City of Corpus Christi

Meeting Agenda - Final

Planning Commission

Wednesday, April 17, 2024

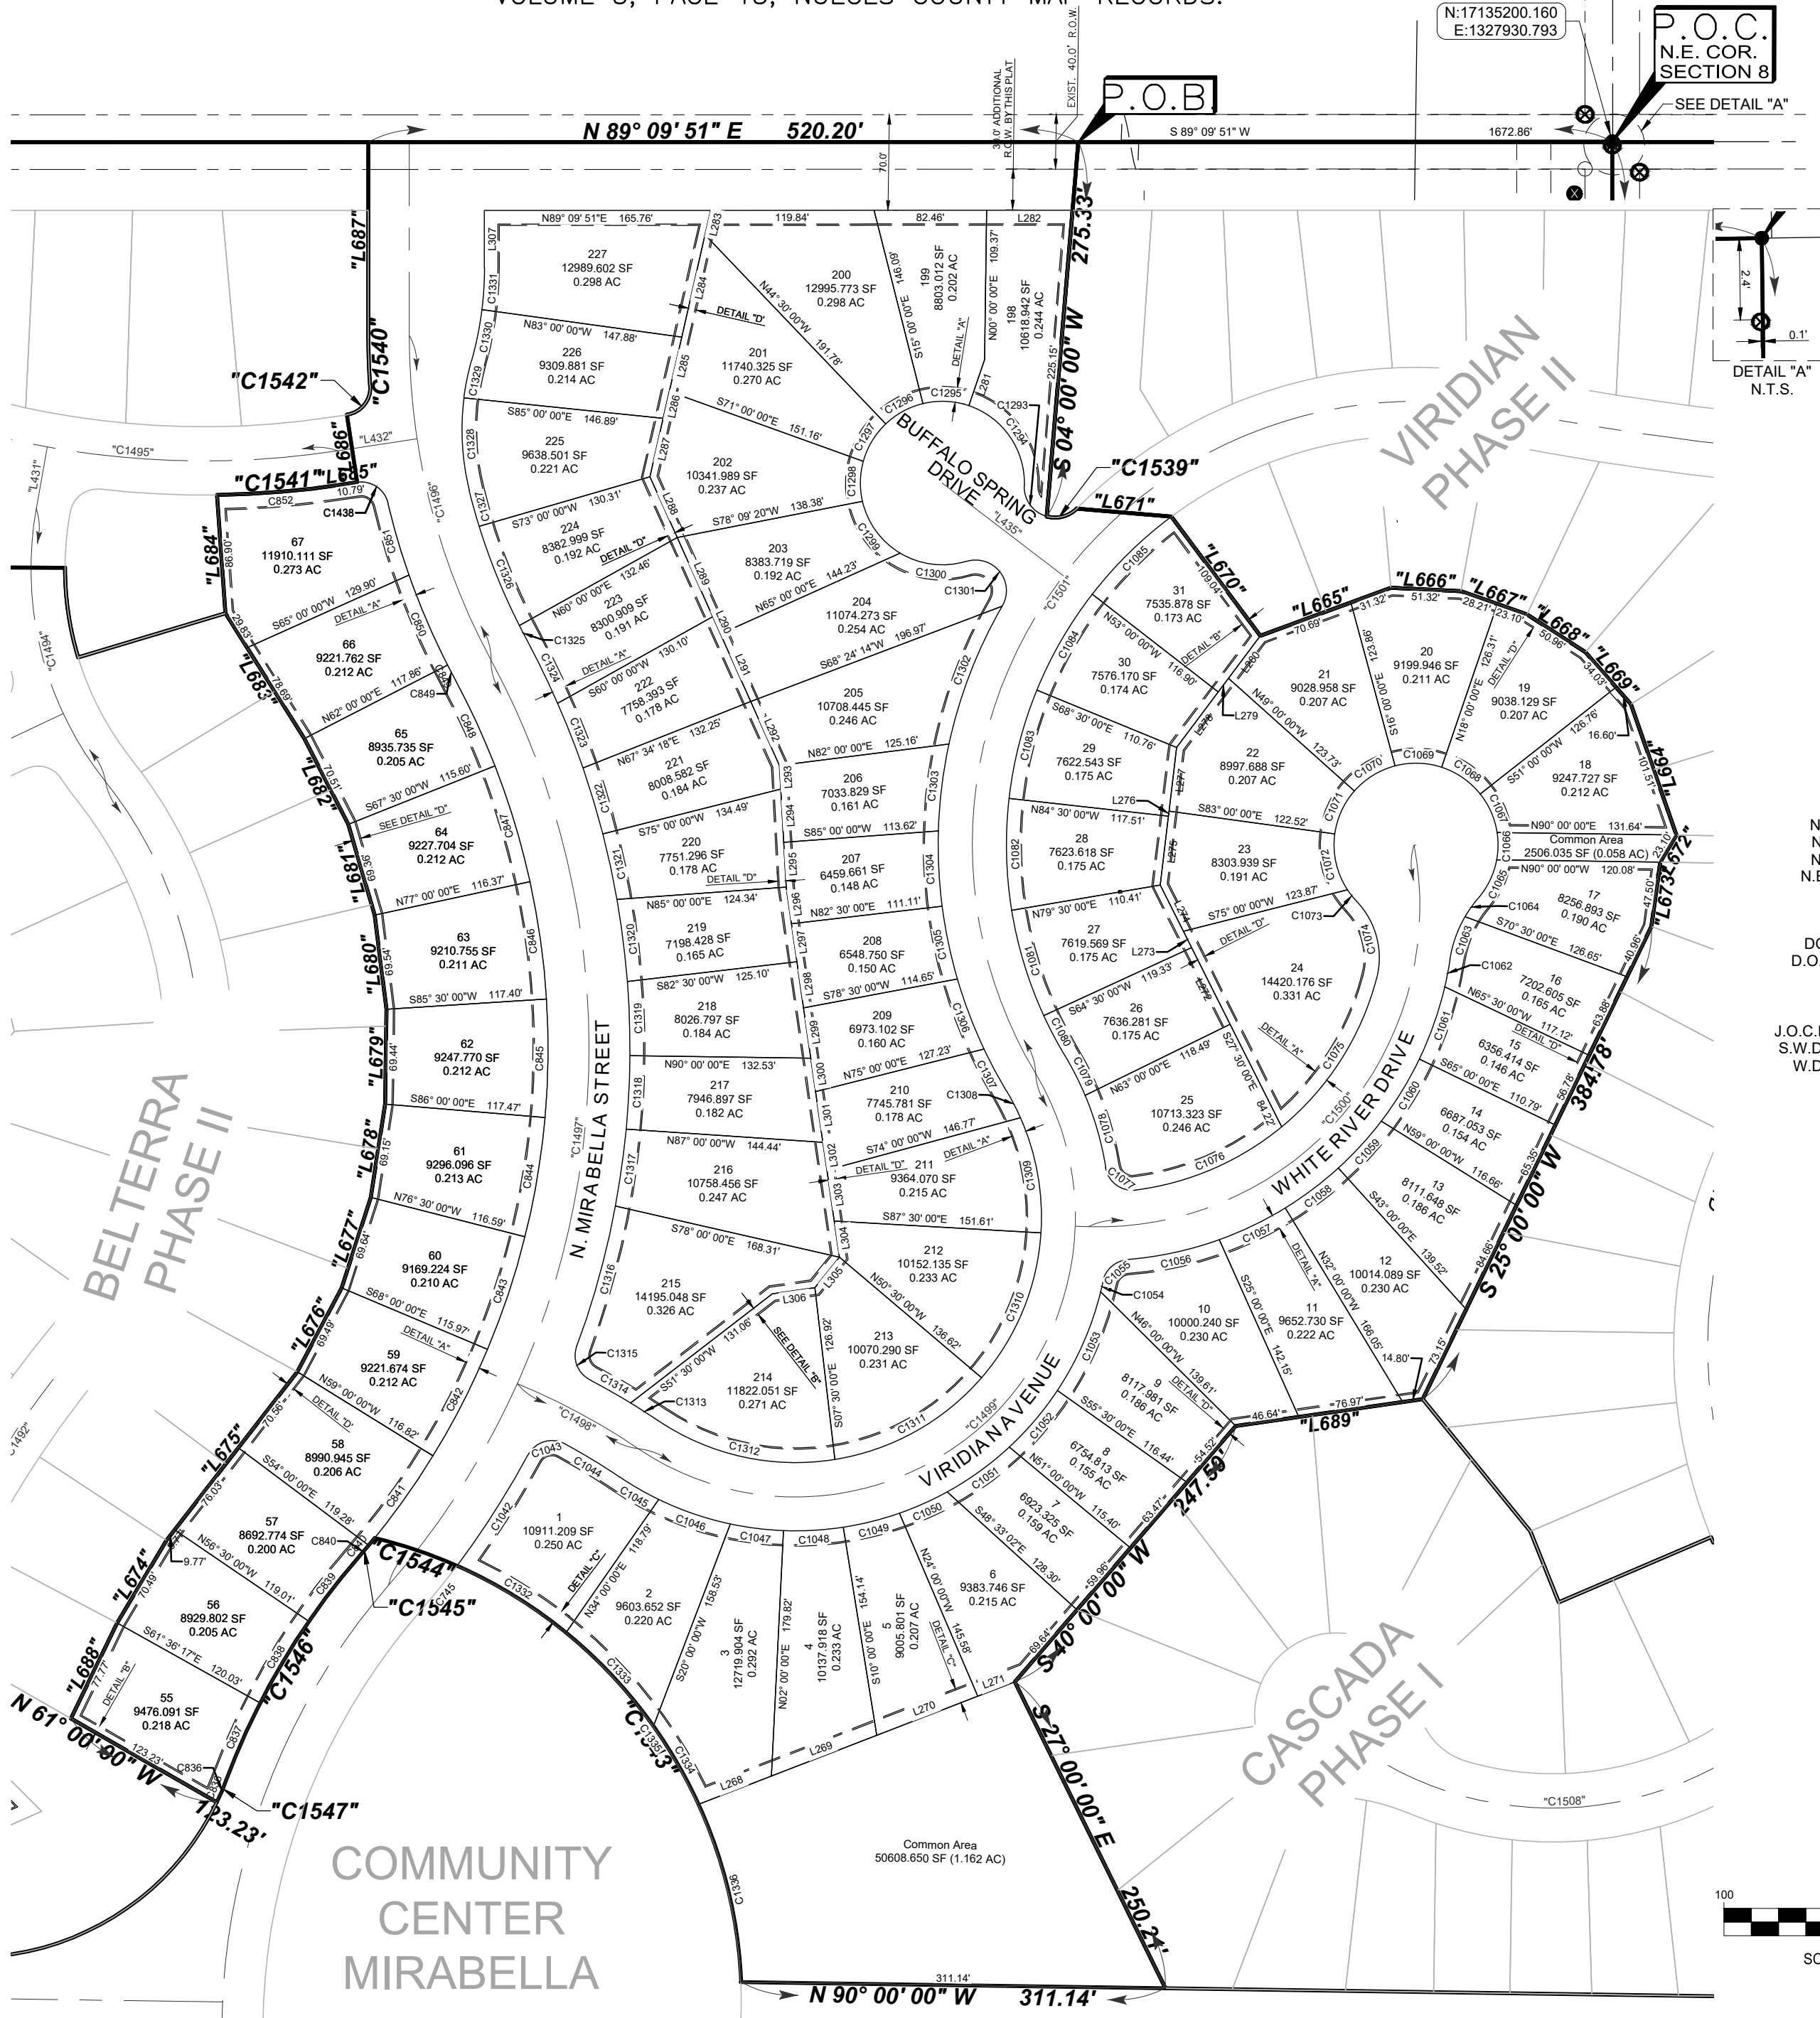
Comment ID	Page Reference	Annotation Type	Author : Department	Status	Review Comments	Applicant Response Comments
1	SHEET 1	Callout	Mark Zans : DS	Open	IChange subdivision map to Final Plat	
2	SHEET 1	Note	Mark Zans : DS	Open	Go to City Of Corpus Christi / Platting website and follow the Final Plat template for plat format.	
3	SHEET 1	Note	Mark Zans : DS	Open	Place square footages of each lot below the lot number.	
4	SHEET 1	Note	Mark Zans : DS	Open	Label the common area as to the use of the area.	
5	SHEET 1	Note	Mark Zans : DS	Open	Provide street names for the streets on this plat. Street names shall match the names that were shown on the preliminary plat.	
6	SHEET 1	Note	Mark Zans : DS	Open	Please label this easement as to type and width.	
7	SHEET 1	Note	Mark Zans : DS	Open	Hatch the area for road way dedication and provide the square footage of the area.	
8	SHEET 1	Note	Mark Zans : DS	Open	Label surrounding parcels with the phase and lots of the other plats.

9	SHEET 1	Callout	Mark Zans : DS	Open	Change Move Up Phase one to plat name that makes sense.	
10	SHEET 1	Note	Mark Zans : DS	Open	Provide block numbers for all blocks within this plat.	
11	SHEET 1	Note	Mark Zans : DS	Open	Remove metes and bounds description from plat. See City of Corpus Christi / Platting for templates to use for final plat format.	
12	SHEET 1	Note	Mark Zans : DS	Open	Please check the acreage of the this plat. Total acreage shown here does not match acreage in subtitle.	
14	SHEET 1	Callout	Mark Zans : DS	Open	Change years in the County Clerks Certification.	
15	SHEET 1	Callout	Mark Zans : DS	Open	Change Chairman's name to Michael Miller	
16	SHEET 1	Callout	Mark Zans : DS	Open	Fix signature line.	
20	SHEET 1	Note	Mark Zans : DS	Open	Increase font size for street names.

Comment ID	Page Reference	Annotation Type	Author : Department	Status	Review Comments	Applicant Response Comments
22	SHEET 1	Note	Mark Zans : DS	Open	Solid Waste Comment- How is waste disposal services to lots 55,56,57 to be done.	
24	SHEET 1	Callout	Mark Zans : DS	Open	Add Phase name to the Crosstown Coves	
25	SHEET 1	Note	Mark Zans : DS	Open	Add phase name to the Crosstown Coves name in the surveyors certificate.	
26	SHEET 1	Note	Mark Zans : DS	Open	<p>TxDOT comments- □No increase in storm water discharge to State right-of-way shall be accepted by TxDOT.</p> <p>□TxDOT Permits will be issued in accordance with the access management standards and all applicable state and federal laws, including rules and regulations. Access connection spacing, materials, geometrics, accessibility, and other design specifications will be considered, as well as the impact on drainage and hydraulics, utility location or relocation, and the environment that will result from the requested construction of an access connection. 43 Tex. Admin. Code 11.52 (2020).</p> <p>□Drainage improvements shall accommodate runoff from the upstream drainage area in its anticipated maximum "build-out" or "fully developed" condition, and shall be designed to prevent overloading the capacity of the downstream drainage system</p> <p>□If the owner responsible for maintenance of the permanent stormwater or water quality control fails to maintain the control to TXDOT ROW, the owner shall correct the problem</p>

27	SHEET 1	Note	Mark Zans : DS	Open	<p>Fire comments - 1- 7</p> <p>1□Infor:□Although presently this proposed subdivision is outside city limits, it is projected to be annexed soon. Consideration should be given to the standards for fire protection as follows:</p> <p>2□Utility□Residential fire flow should have at least 750 GPM with fire hydrants spaced every 600 feet.</p> <p>3□Infor:□503.2.3 Surface. Fire apparatus access roads should be designed and maintained to support the imposed loads of fire apparatus and shall be surfaced to provide all weather driving capabilities and capable of supporting the imposed load of fire apparatus weighing at least 75,000 pounds.</p> <p>4□Infor:□IFC 2015 Sec. 503.2.1 Dimensions Fire apparatus access roads shall have an unobstructed width of not less than 20 feet, exclusive of</p>

28	SHEET 1	Note	Mark Zans : DS	Open	<p>Fire comments 8-14</p> <p>8 Infor, To negotiate a turn in a cul-de-sac, the minimum required distance is a 96 ft diameter in accordance with section 503.2.5 Dead ends. Dead-end fire apparatus access roads more than 150 feet (45 720 mm) in length shall be provided with an approved area for turning around fire apparatus. Turn around provisions shall be provided by means of a 96-foot diameter cul-de-sac (Section 503.2 and Appendix D. Cul -de -Sac turning diameter shall be 96 minimum.)</p> <p>9 Infor, Note: An accessible road and a suitable water supply is required once construction materials are brought on site.</p> <p>10 Infor: 503.4 Obstruction of fire apparatus access roads. Fire apparatus access roads shall not be obstructed in any manner, including the parking of vehicles. The minimum widths and clearances established in sections D103 shall always be</p>

29	SHEET 1	Note	Mark Zans : DS	Open	Park De. Fee: 74 lots x 462.50 = \$34,225.00	
30	SHEET 1	Note	Mark Zans : DS	Open	AEP Texas Distribution request a 5 electric easement in the front of every lot off the ROW for front lot distribution. It can be the first 5 or the second behind a UE if there is one.	
33	SHEET 1	Note	Mark Zans : DS	Open	<p>Traffic comments- 1 -8</p> <p>1 Plat Lack of Public Infrastructure Plans present difficulty to justify variable right-of-way widths internal to the subdivision.</p> <p>2 Informational: All new streetlight systems in residential subdivisions shall utilize concrete poles per IDM Chapter 8 section 1.2.B.a</p> <p>3 Plat Curvilinear nature of Roadway layout may require lighting above and beyond the minimum 500 ft spacing</p>

38	SHEET 1	Note	Mark Zans : DS	Open	It is DSD understanding that the zoning for this plat will be RS-4.5 Front yard setback for RS 4.5 zoning is 20 feet. Please depict and label a front yard setback of 20' for each lot.

Comment ID	Page Reference	Annotation Type	Author : Department	Status	Review Comments	Applicant Response Comments
39	SHEET 1	Note	Mark Zans : DS	Open	GIS comment- The plat does not close within acceptable engineering standards.	
17	SHEET 2	Callout	Mark Zans : DS	Open	IChange subdivision map to Final Plat	
18	SHEET 2	Callout	Mark Zans : DS	Open	Change Move Up Phase i to plat name that makes sense.	
19	SHEET 2	Note	Mark Zans : DS	Open	Increase font size foe street names	
21	SHEET 2	Callout	Mark Zans : DS	Open	Ffix Signature line.
